Access Compliance Report

Public Rights-of-Way

Intersection ID: 7375	Main Street: TRYON_ST	Cross Street: TOM_HUNTER_RD	Location: NW
ADA ID: 20047B83120A	Ramp Type: Directional1	Initial Pass/Fail: Pass	Overall Compliance: No
		Severity Score: 0.25

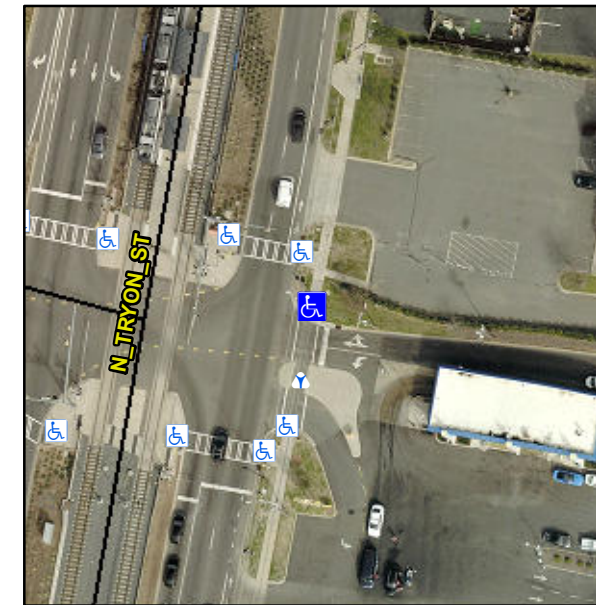
R304.5.2

Compliance	Description	Data	Compliance	Description	Data
N/A	Ramp Length (in)	103.0	No	Grade Break?	No
Yes	Ramp Width (in)	64.0	N/A	Grade Break Slope (%)	N/A
Yes	Ramp Slope (%)	4.3	N/A	Grade Break XSlope (%)	N/A
Yes	Ramp XSlope (%)	3.0			
Yes	Flare Type LT	N/A	Yes	Flare Type RT	N/A
N/A	Flare Slope LT (%)	N/A	N/A	Flare Slope RT (%)	N/A
N/A	Flare Traversable LT?	No	N/A	Flare Traversable RT?	No
Yes	Landing Length (in)	61.0	Yes	DWS Provided?	Yes
Yes	Landing Width (in)	68.0	Yes	DWS Contrast?	Yes
Yes	Landing Slope (%)	2.0	Yes	DWS Length (in)	24.0
Yes	Landing X Slope (%)	2.3	Yes	DWS Full Width?	Yes
N/A	Landing Curb? (Y/N)	N/A	Yes	DWS Offset LT (in)	2.0
N/A	Shared Landing?	No	Yes	DWS Offset RT (in)	2.0
Yes	Gutter Ponding?	No	Yes	Gutter Slope (%)	2.7
Yes	Gutter Lip Ht (in)	0.0	Yes	Gutter X Slope (%)	3.6
N/A	Painted X Walk1?	Yes		Road Slope (%)	0.2
	X Walk 1 Direction	To S		Road X Slope (%)	5.5
	X Walk 1 Width (in)	116.0		Clear Space?	Yes

Remove & Replace Entire Ramp.
